ADDENDUM No. 2

RFP No. 25-39

High-Level Trunkline Capacity Improvements

REV. NO.	DATE	DRAWN BY	CHECKED BY
STEEL PIPE BOLLARD			
DR. ENG	CH. ENG	DRAWING NO.	
SCALE N.T.S.	DATE 12/8/2023	SD-M-3

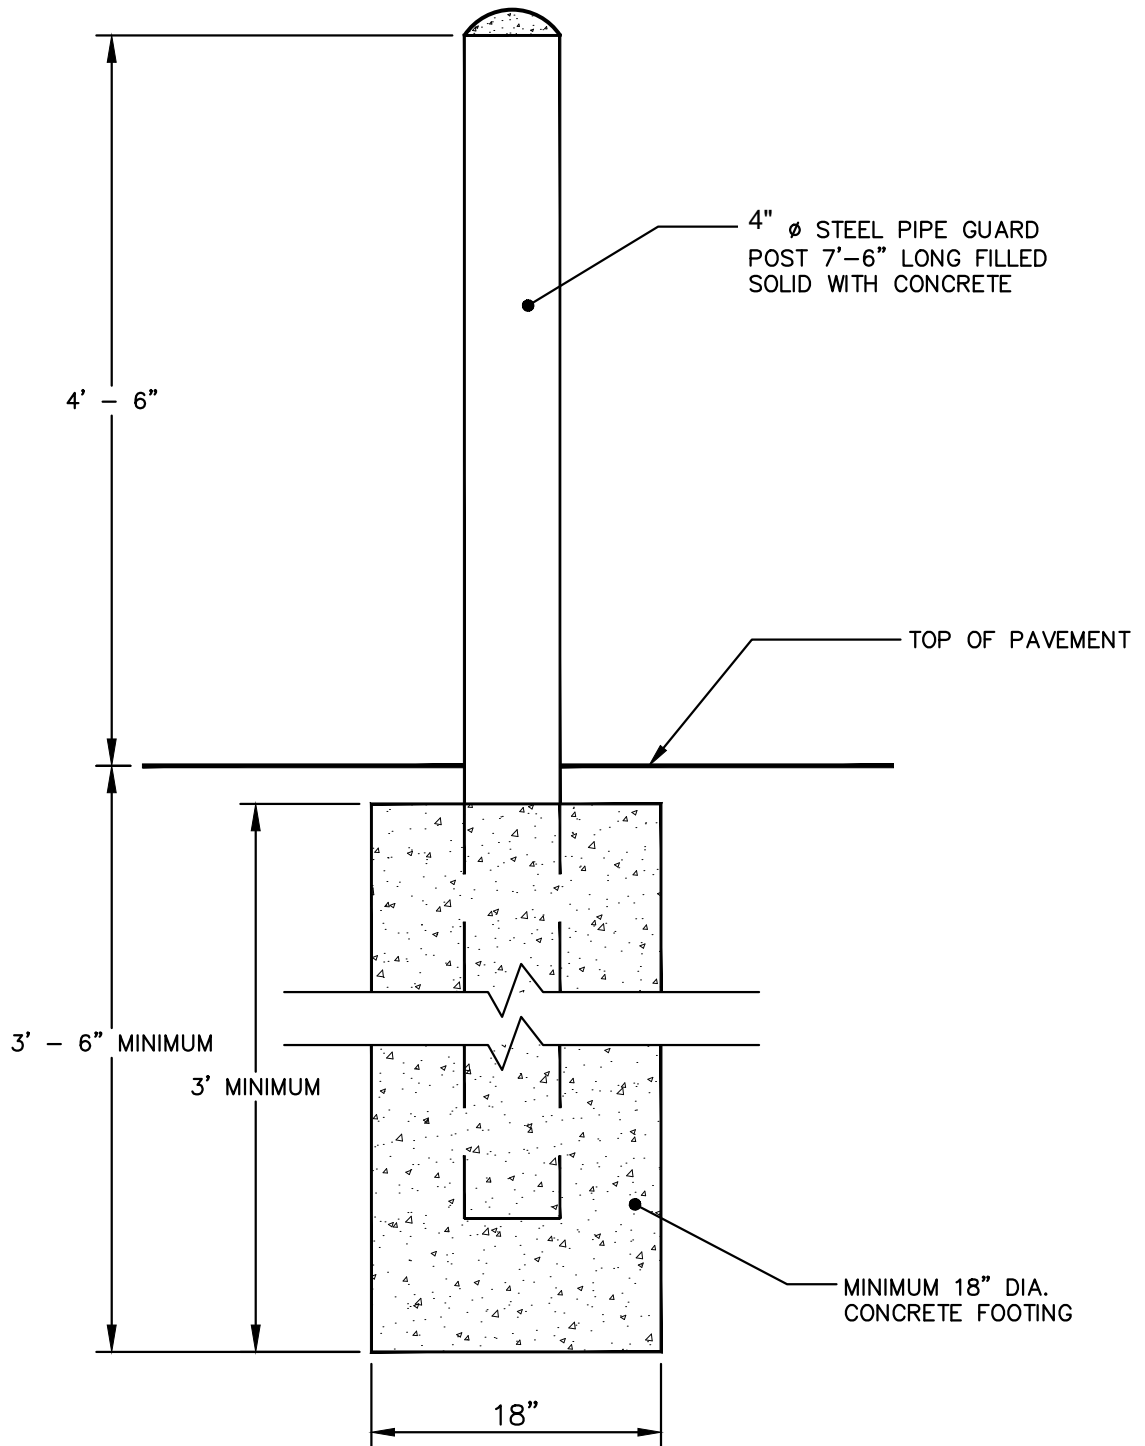
a. Description. This work consists of removing, fabricating, delivering and installing concrete-filled steel pipe bollards and high-density polyethylene (HDPE) bollard covers.

c. Construction. Fabricate the bollard to the dimensions shown on the plans. Prior to installing grind all sharp edges to a minimum 3/32 inch radius

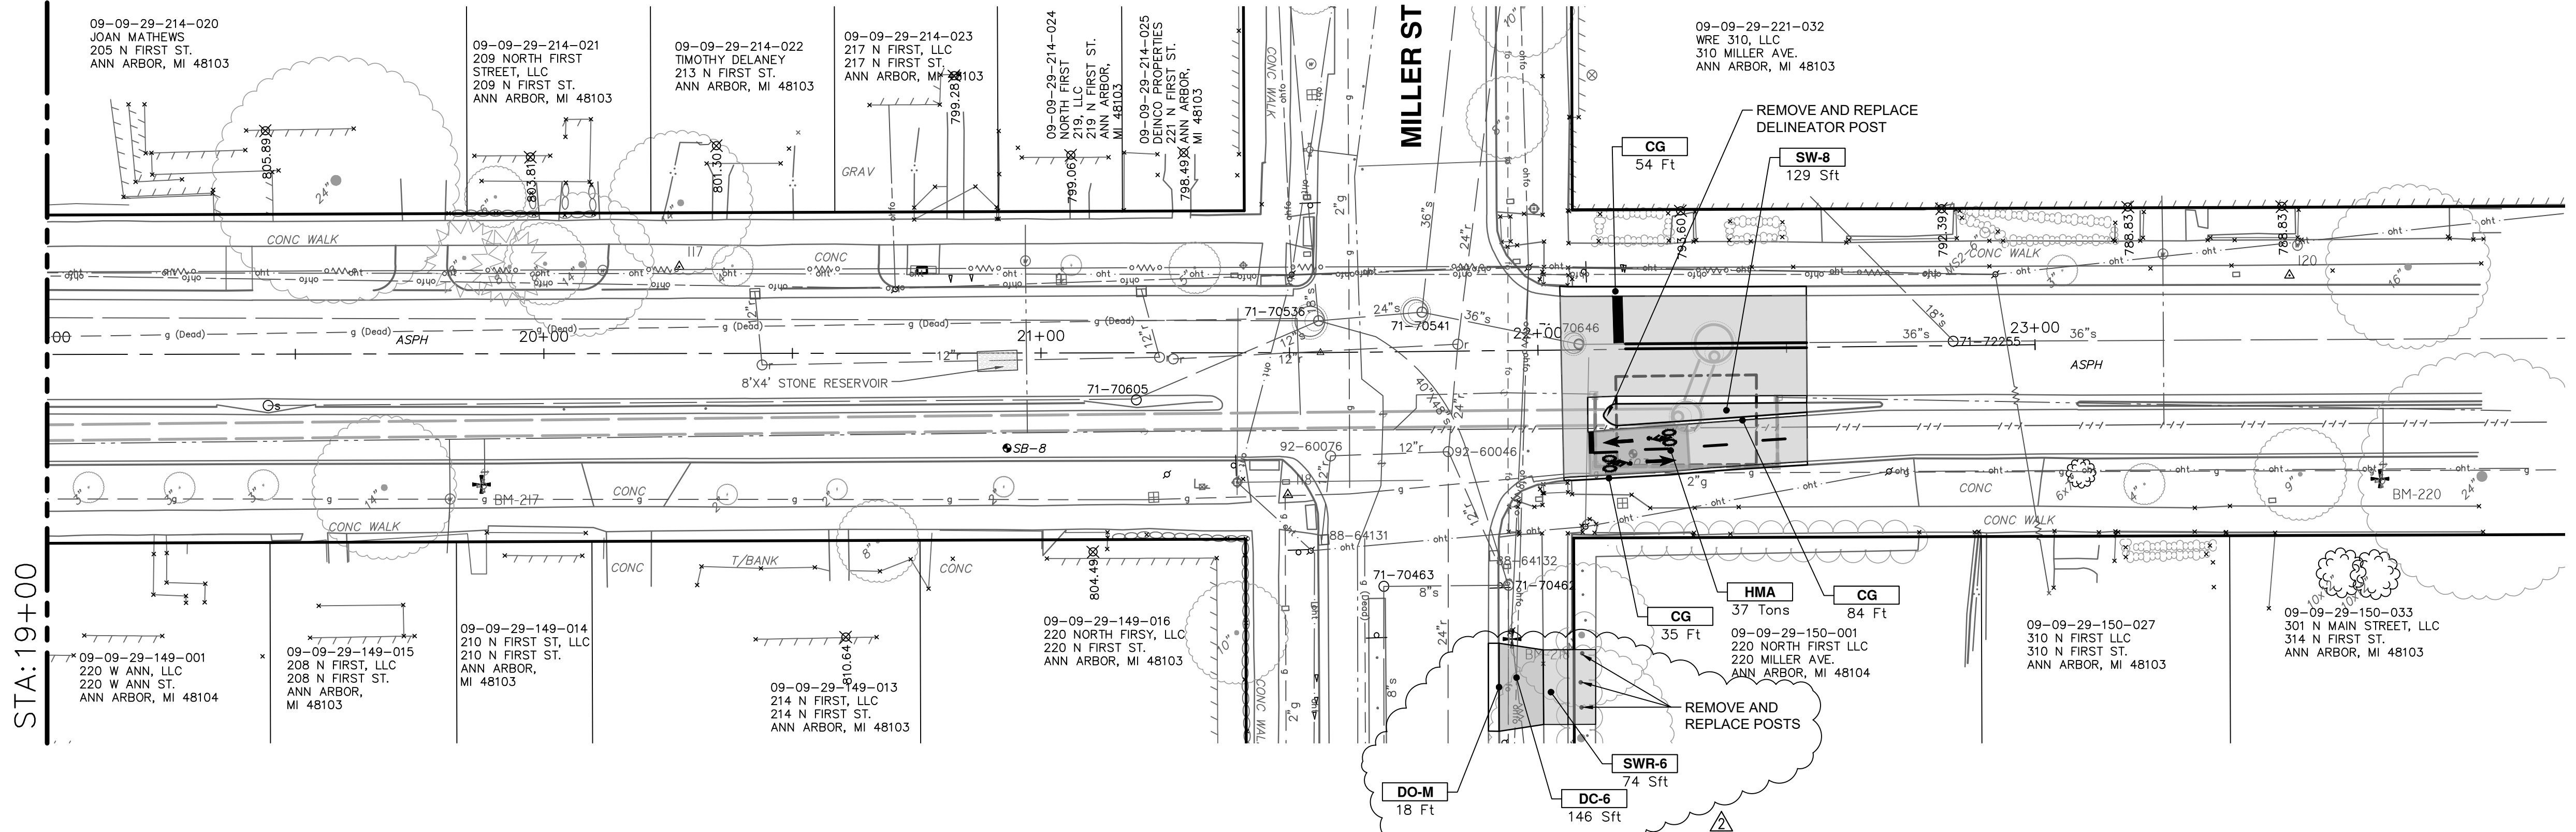
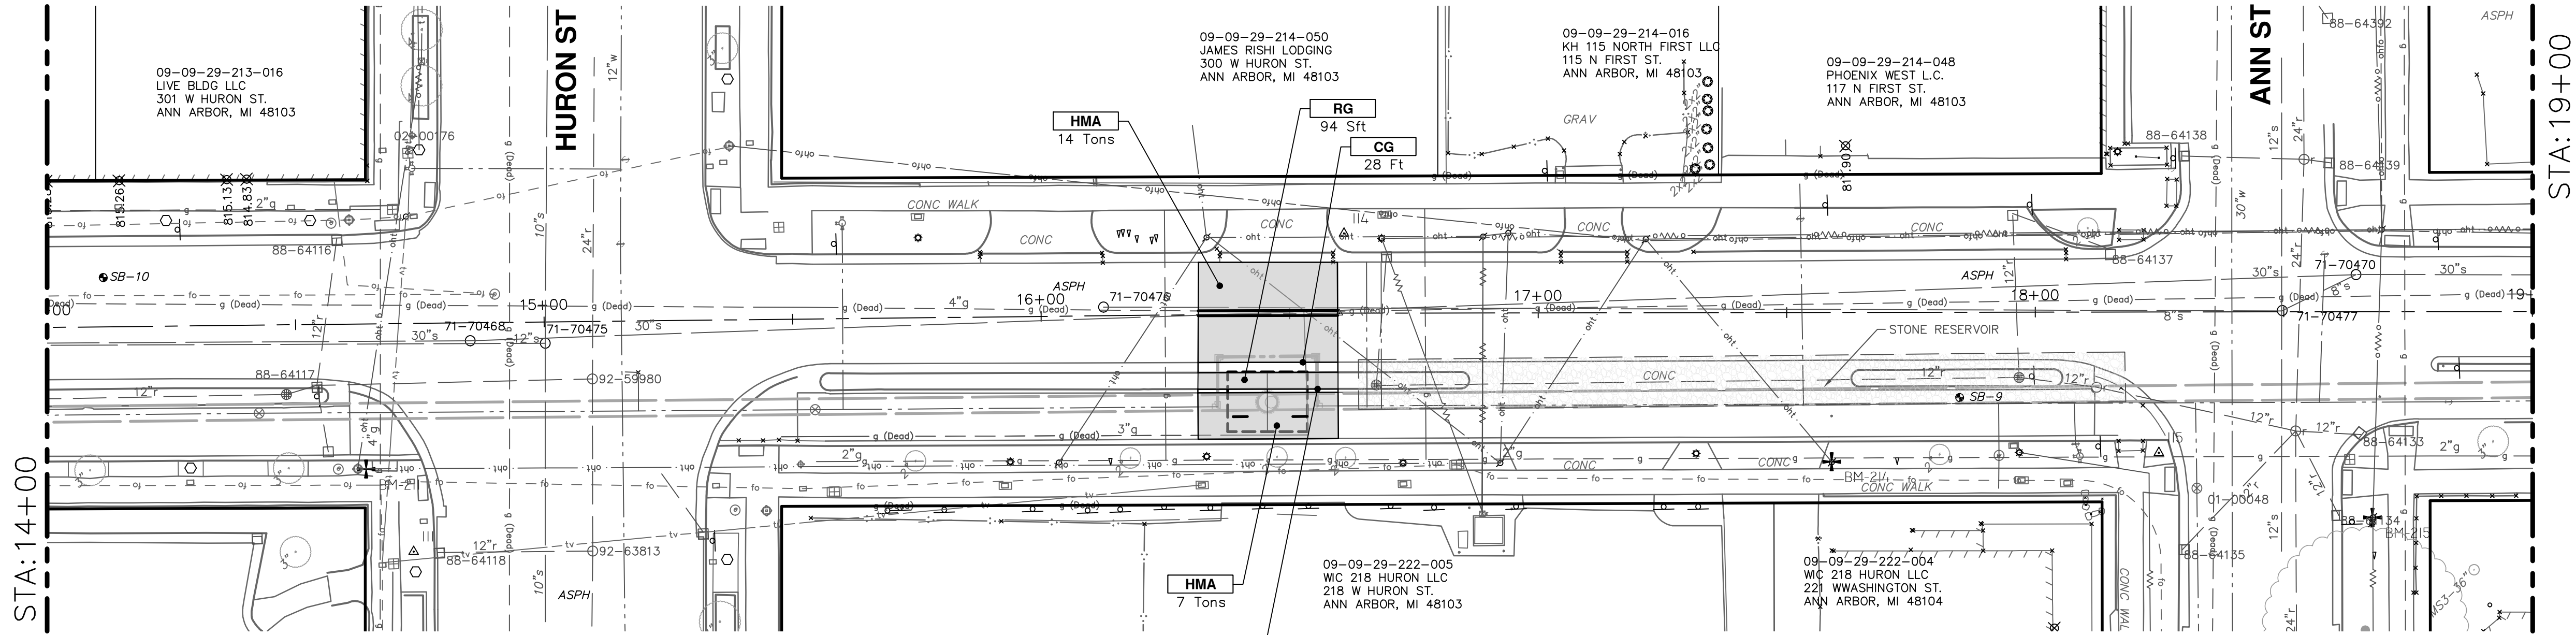
RFP 25-39 Plans,
Sheets 17, 18 and 21

Replace in their entirety.
